Planning, Transport & Sustainability Division
Planning and Rights of Way Panel 14th January 2014
Planning Application Report of the Planning and Development Manager

Application address: Sewage Works, Victoria Road, Woolston			
Proposed development: Redevelopment of the site. The provision of a permanent wastewater treatment works, comprising a primary, secondary and sludge treatment building and associated ancillary structures, internal access roads with realignment of Victoria Road access, landscaping, lighting, boundary treatments and remedial works to the existing sea wall with new storm outfall and upgrade the existing wastewater treatment works. Proposals include provision of associated temporary construction compound, barge and enabling works (including temporary wastewater treatment plant) with temporary construction worker parking on land to the east of Victoria Road - Description amended following validation.			
Application number	13/01515/FUL	Application type	FUL
Case officer	Stephen Harrison	Public speaking time	15 minutes
Last date for determination:	31.01.2014 (PPA)	Ward	Woolston

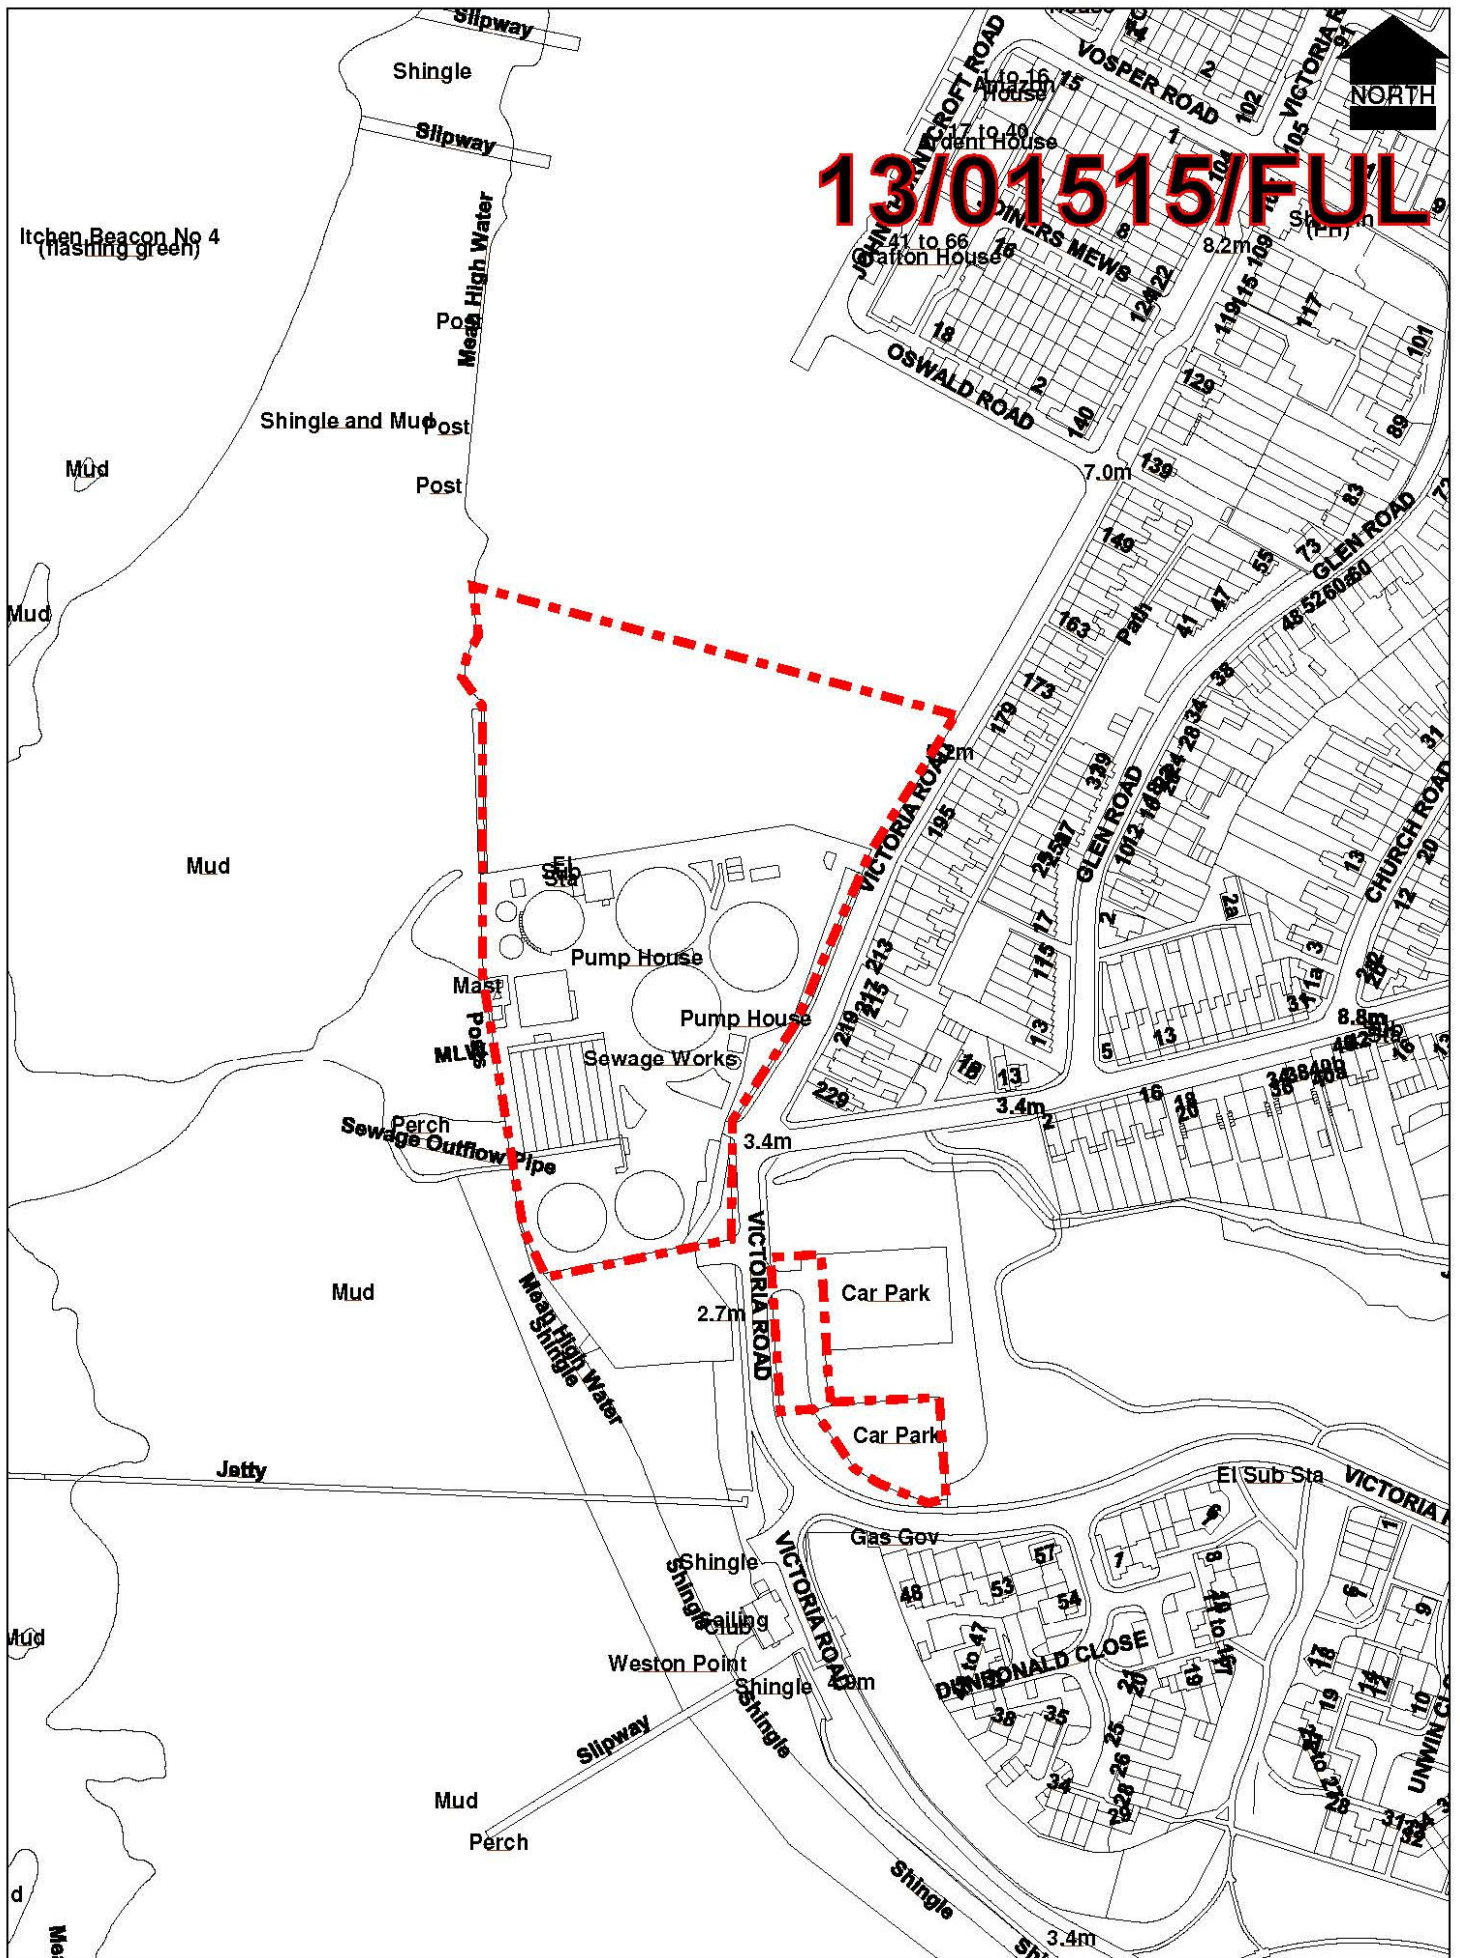
The architects have responded well to pre application advice in developing a more streamlined design with curved supports to the vent stack that complement the aerodynamics of the primary enclosure roof structure.

The overall colour scheme of neutral coloured, perforated or self finished products is welcomed as these will minimise the impact when viewed against the sky. The proposal to use a standing seam aluminium cladding system with an embossed finish (and therefore minimal maintenance due to an unpainted finish) is supported subject concerns expressed at pre application stage that this might initially be highly reflective and a risk to nearby bird habitats. Examples to show where this sort of product has weathered well should be provided.
